**JUNE 2021 FINAL MND SCH #2020100267**

**JUNE 2021 FINAL MITIGATED NEGATIVE DECLARATION/INITIAL STUDY  
FOR AMERESCO KELLER CANYON RNG LLC – PROPOSED RENEWABLE  
NATURAL GAS PROCESSING FACILITY AND PIPELINE PROJECT  
SCH #2020100267  
LAND USE PERMIT LP18-2022  
JUNE 23, 2021**

This document constitutes the Final Mitigated Negative Declaration/Initial Study (MND), State Clearinghouse SCH #2020100267, for the Ameresco Keller Canyon RNG LLC – Proposed Renewable Natural Gas Processing Facility and Pipeline Project (Ameresco RNGPFP) in unincorporated Contra Costa County near Pittsburg, CA. The proposed project is a renewable natural gas (RNG) processing facility (RNGPF) and pipeline that includes construction and operation of a new RNGPF and an underground transmission pipeline. The Final MND includes a revised project description, summary responses addressing the project description and potential impacts, the written comments received on the November 2020 re-noticed draft MND, responses to the comments received, and staff-initiated text changes including changes resulting from the preparation of responses to comments received and revised and/or deleted figures. The text changes are

**PLAT 4 (REVISED FROM MND FIGURE 18)  
 ACCESS AND LAYDOWN AREAS DURING PIPELINE CONSTRUCTION**

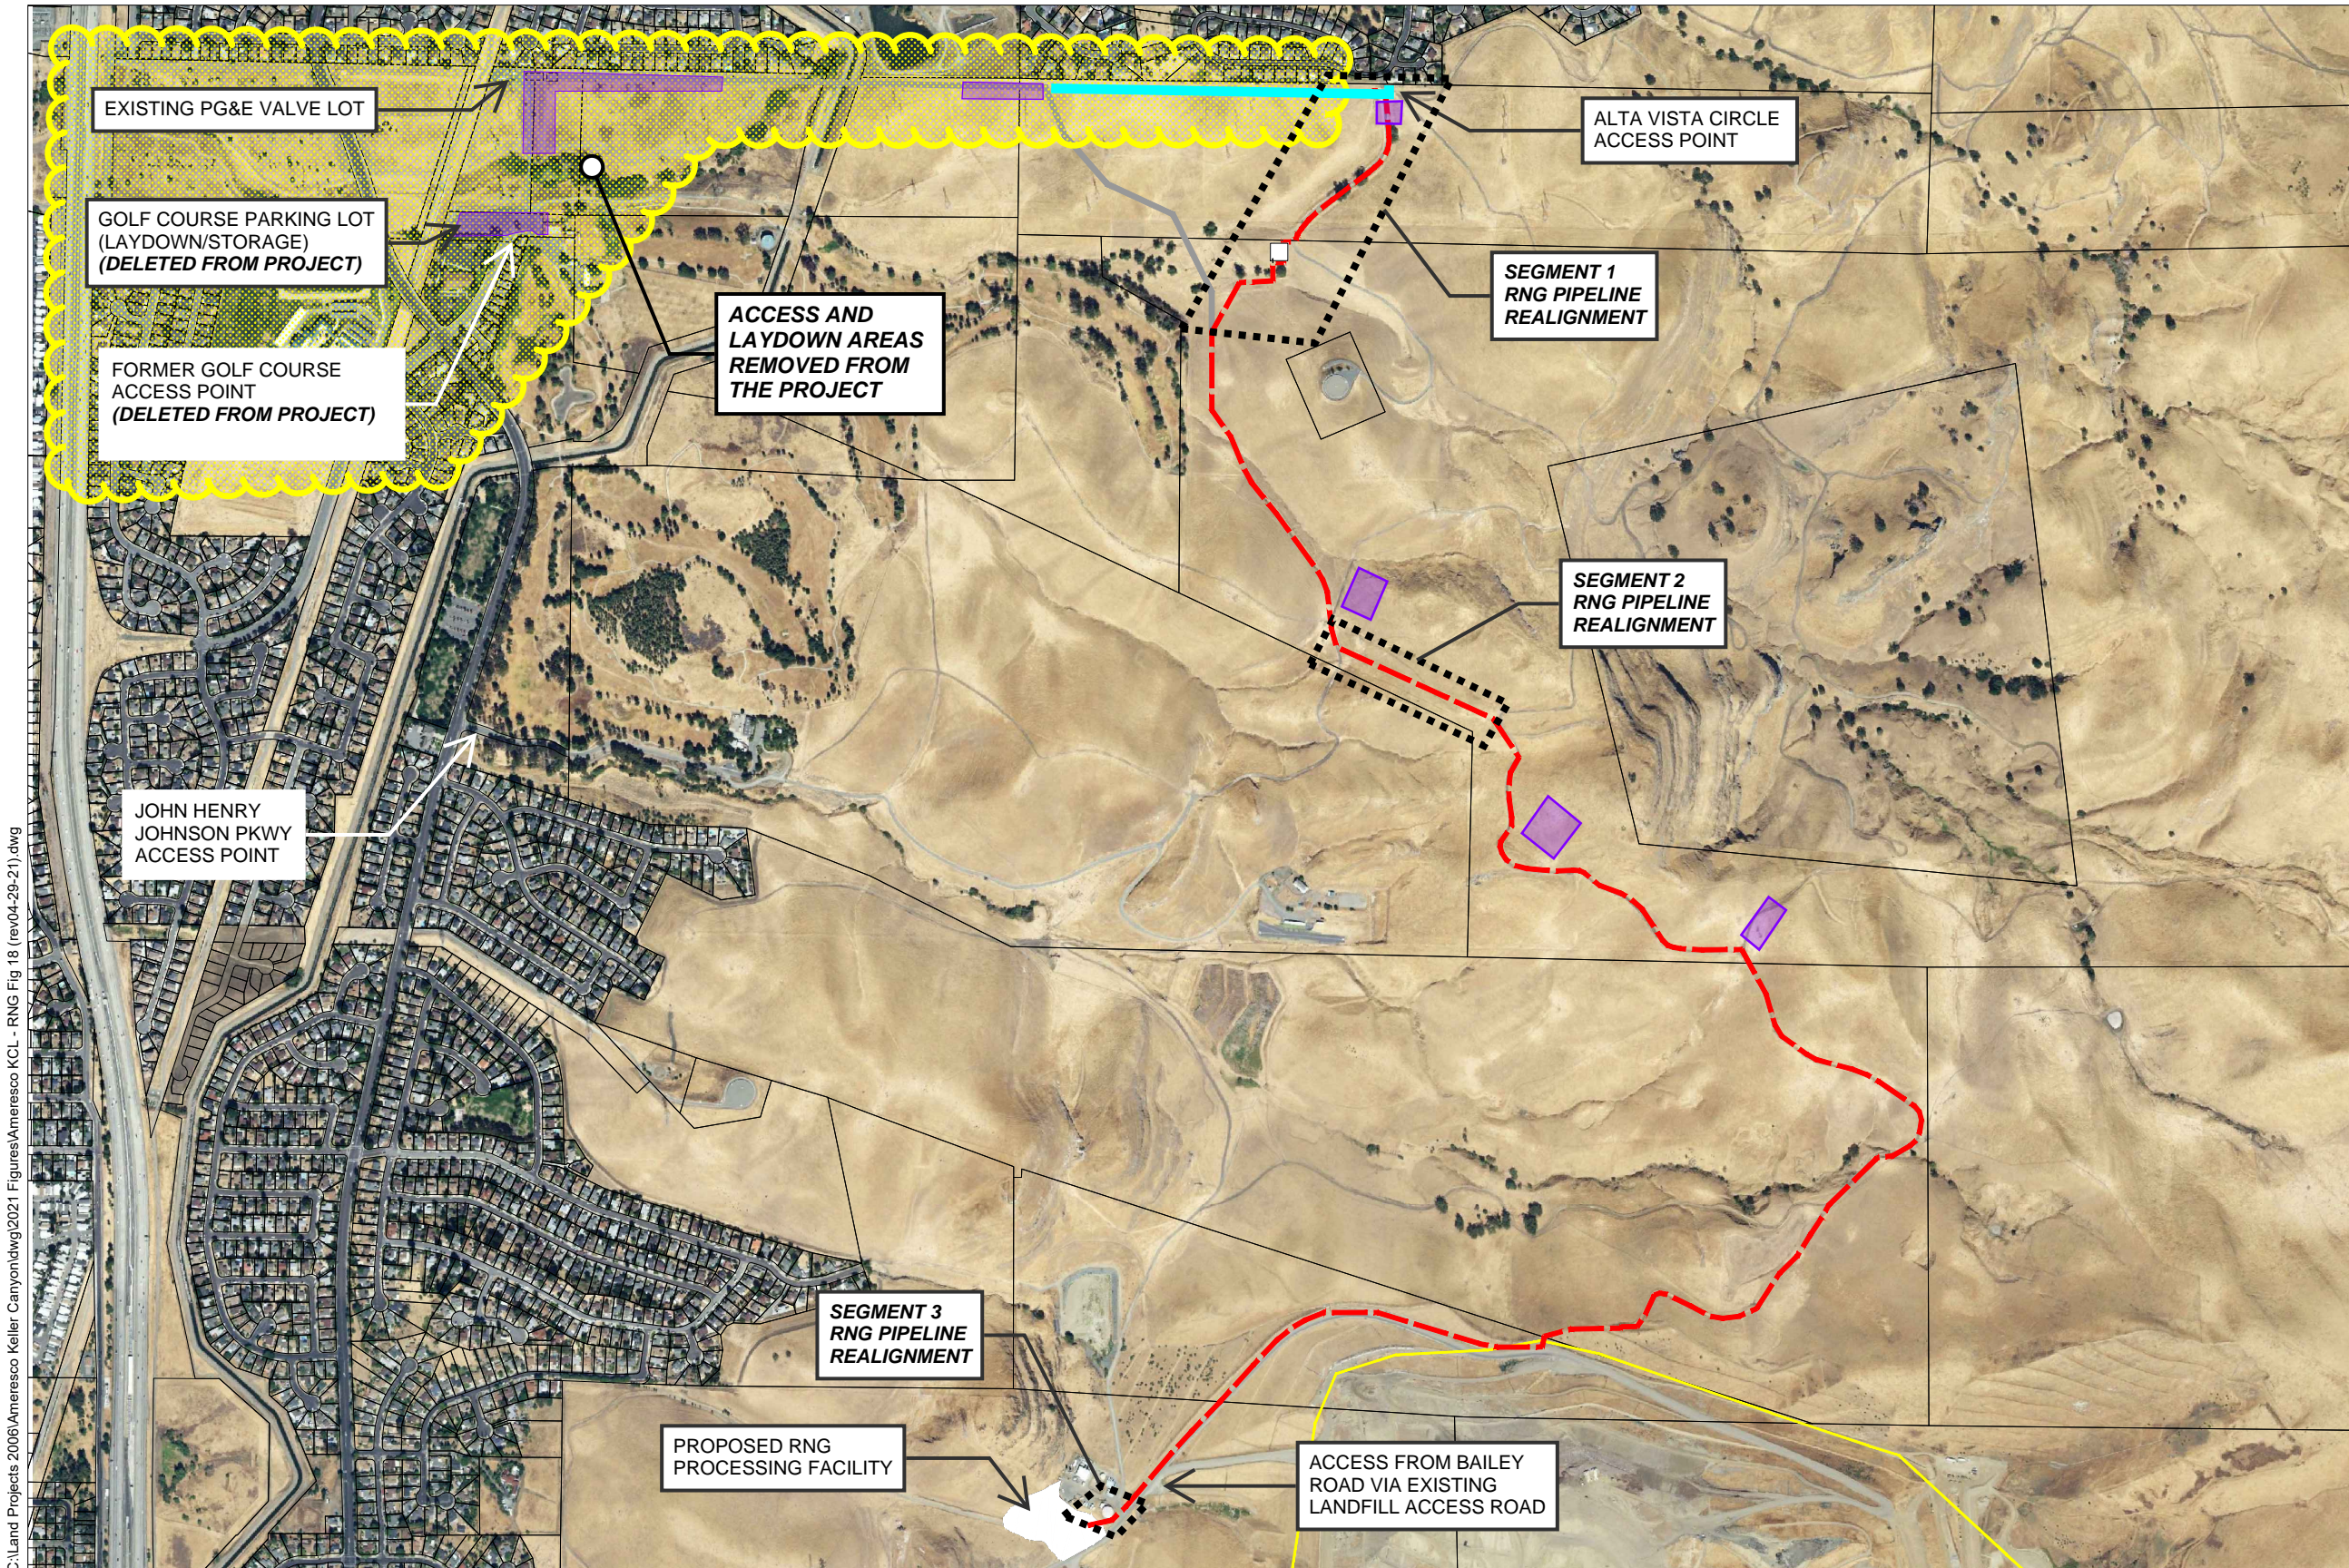
- Shorten the project pipeline construction duration and reduce the overall potential for impacts during pipeline construction.
- Eliminate four (4) construction equipment and material laydown areas within the Pittsburg city limit and near residences thereby reducing potential impacts related to construction and operation of each laydown area as shown on Plat 4 (revised MND Figure 18 – Access and Laydown Areas During Construction).

PLAT 5  
 PROPOSED RNG/PG&E LINE 191-1 TIE IN (LOOKING SOUTH)

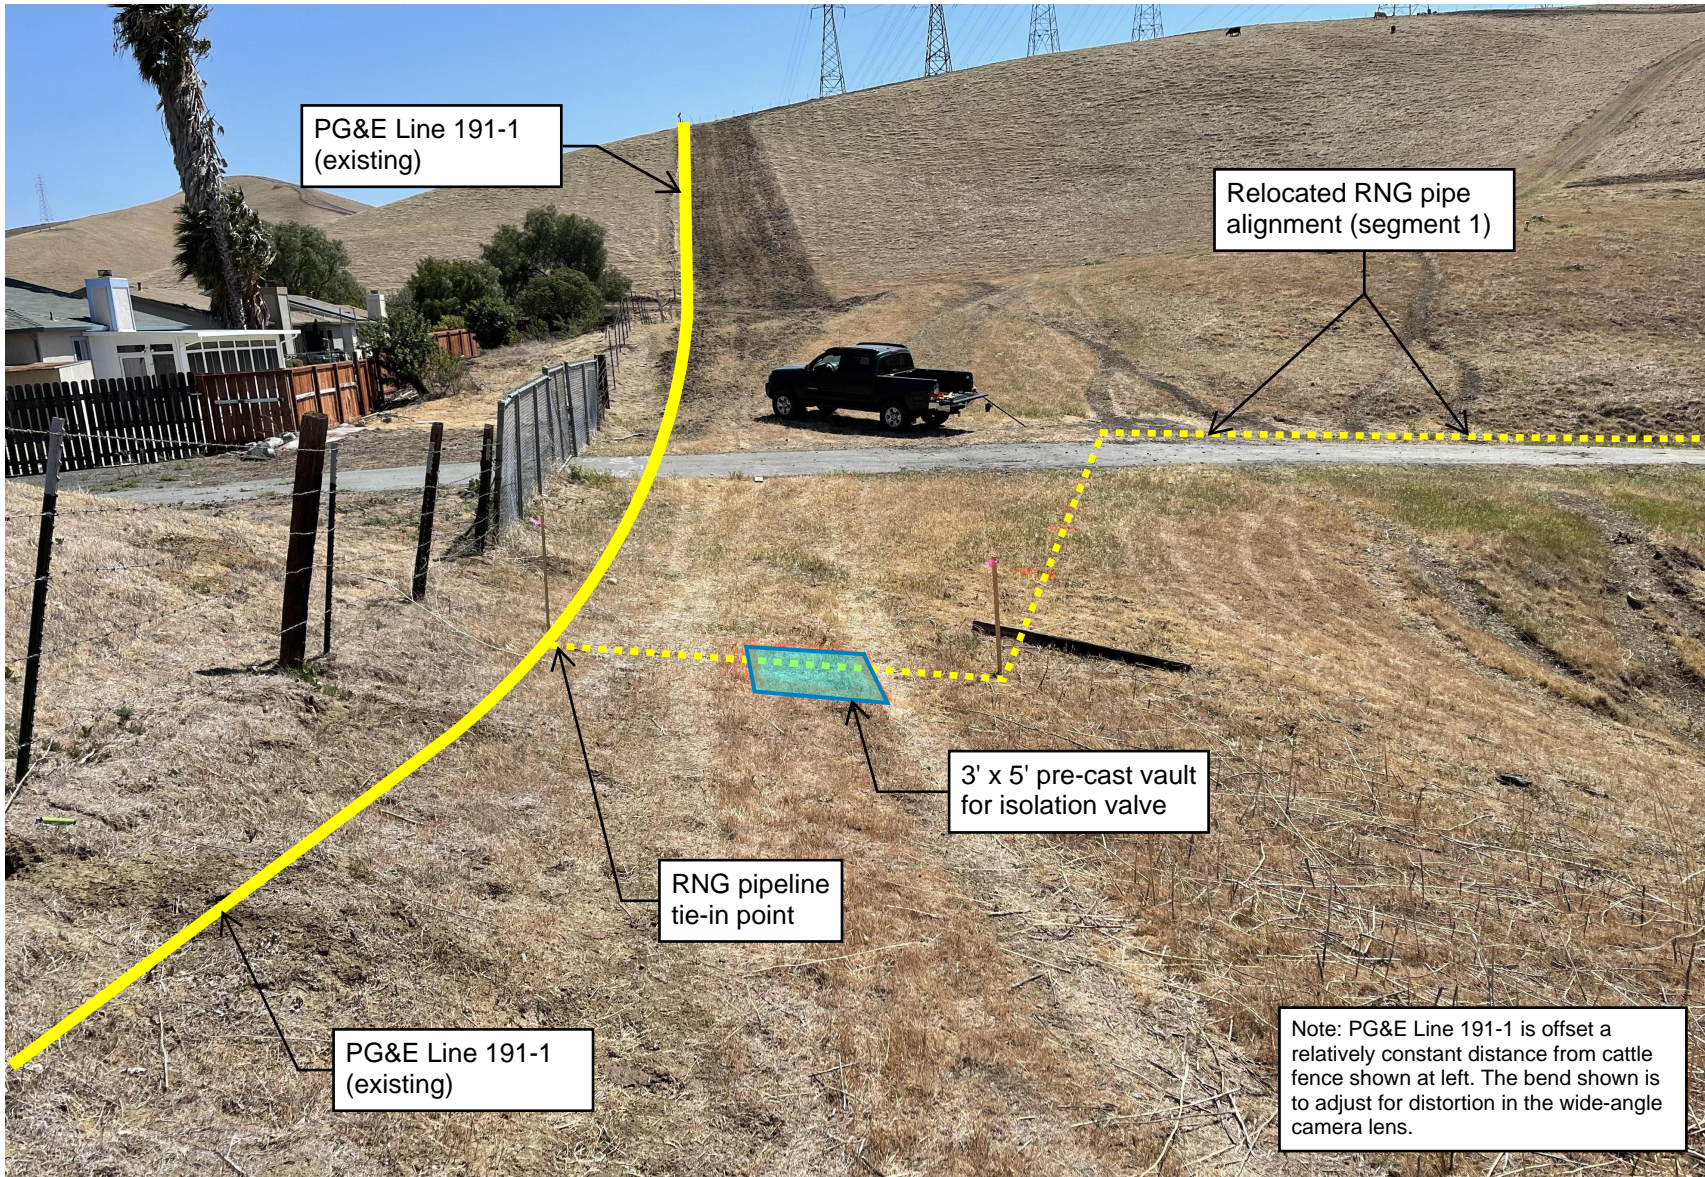
Further, preliminary information was received from PG&E as to their preferred tie-in location. Additional data were received from the pipeline design engineer regarding tie-in design, construction requirements, and operating data assumptions. The general location of the tie-in is shown on Plat 2. A ground plane photograph of the tie-in location is shown on Plat 5.

## PLAT 7 - REVISED PIPELINE ROUTE SEGMENT 3 RNG PIPELINE CONNECTION AT PROCESSING FACILITY

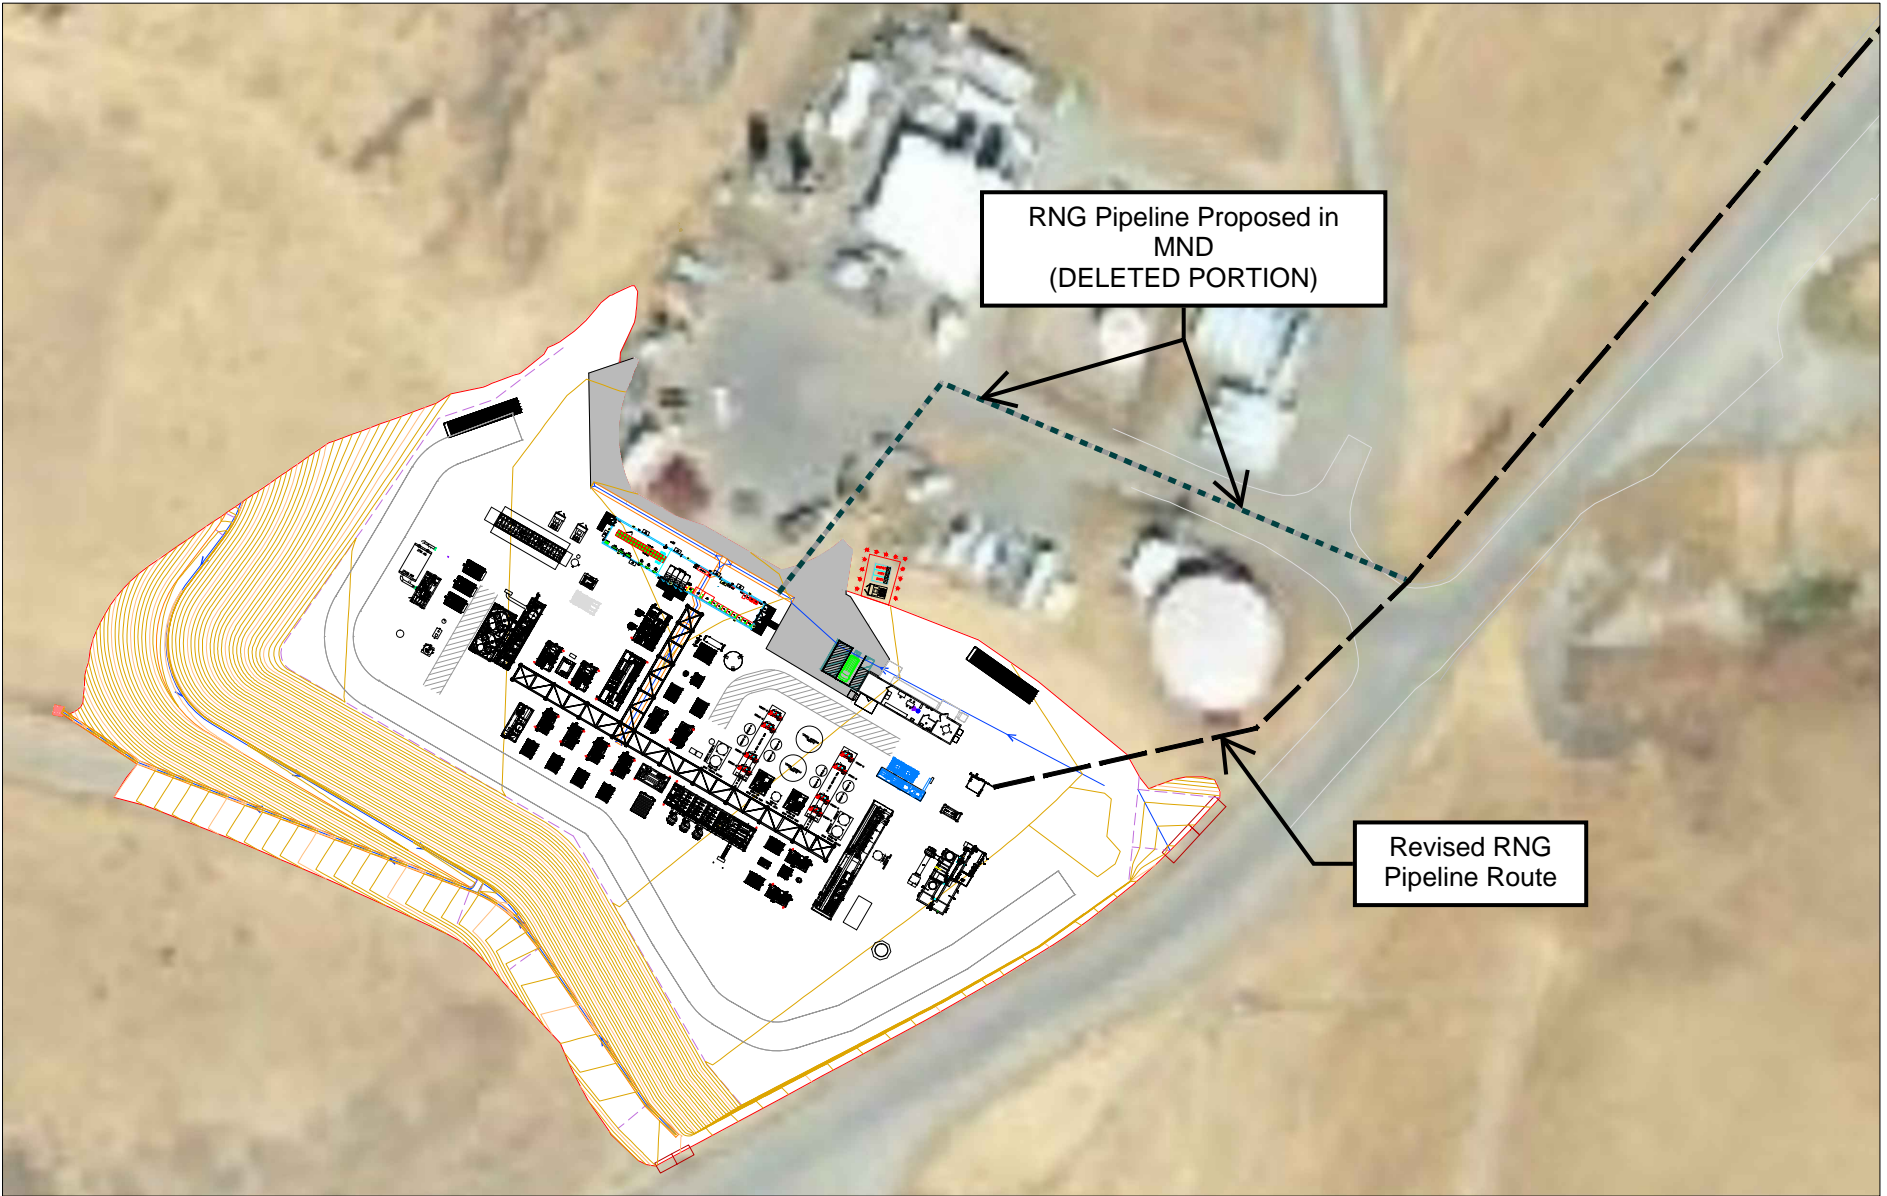
The project revision in Segment 3 comprises a change in RNG pipeline alignment where it would connect to the RNG Processing Facility as shown on Plat 7. This revision was required to minimize potential impacts on landfill operations and to increase physical separation between the RNG pipeline and existing and future underground utilities. No new significant impacts would result from this revised segment.

## RNG PROCESSING FACILITY ROLE IN LANDFILL GAS ABATEMENT

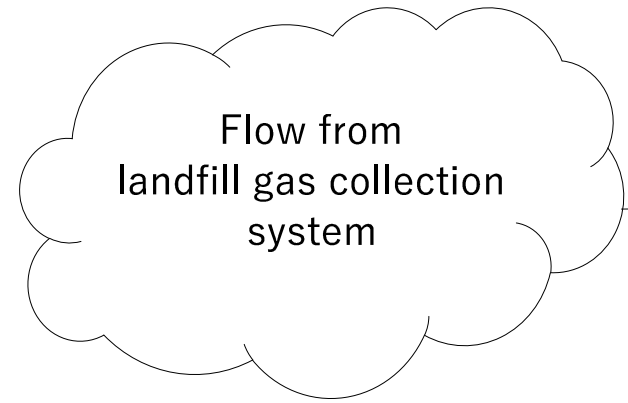
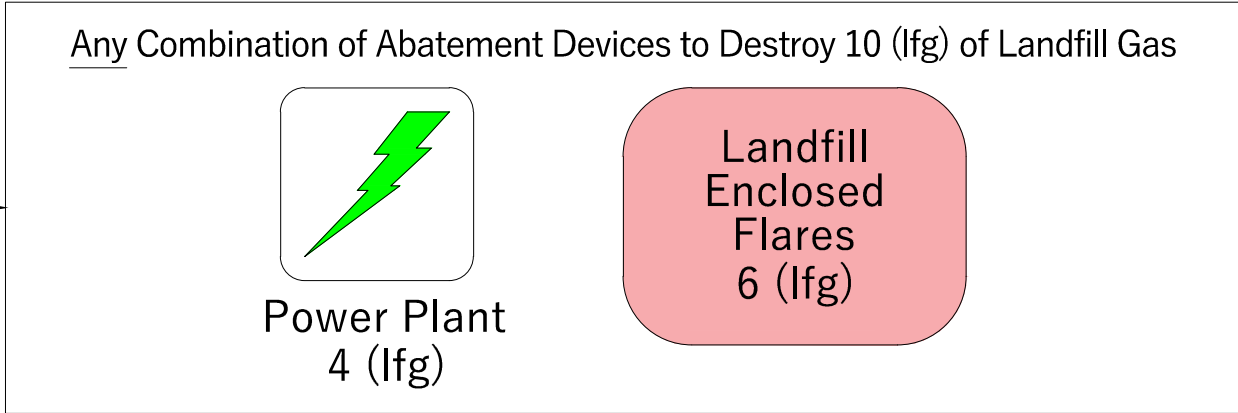
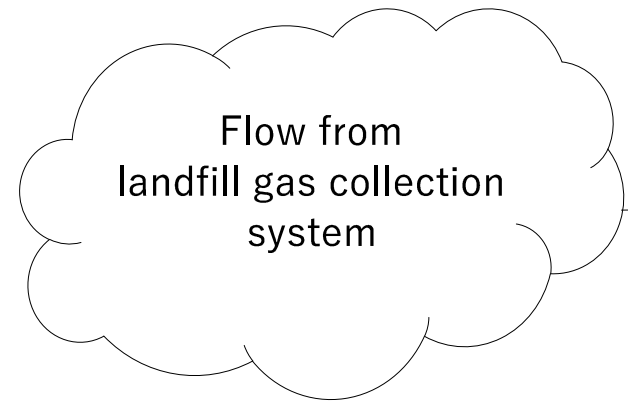
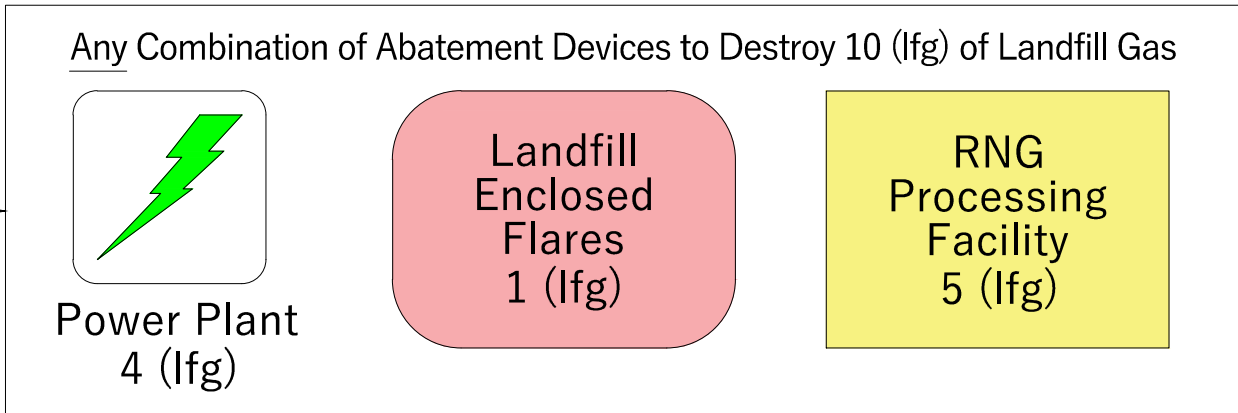
*Comment*: Several comments suggested a misunderstanding of how the proposed RNGPF operation would be related to operation of the existing landfill flares and LFGTE power plant. Also see summary response provided above under D. Project Design, "Abatement" on this issue.

- *Landfill Gas Management with the Project*: Extending the example above, the proposed project adds the RNGPF to the existing LFGTE plant and enclosed flares as an available gas destruction device. When the RNGPF is in operation, landfill gas will continue to be used in the operation of the existing LFGTE plant; and 0 cfm would be burned in the enclosed flares. Please see Summary Responses in D. Project Design, "Abatement" above for additional discussion and a graphic depiction of the existing and proposed landfill gas utilization systems.
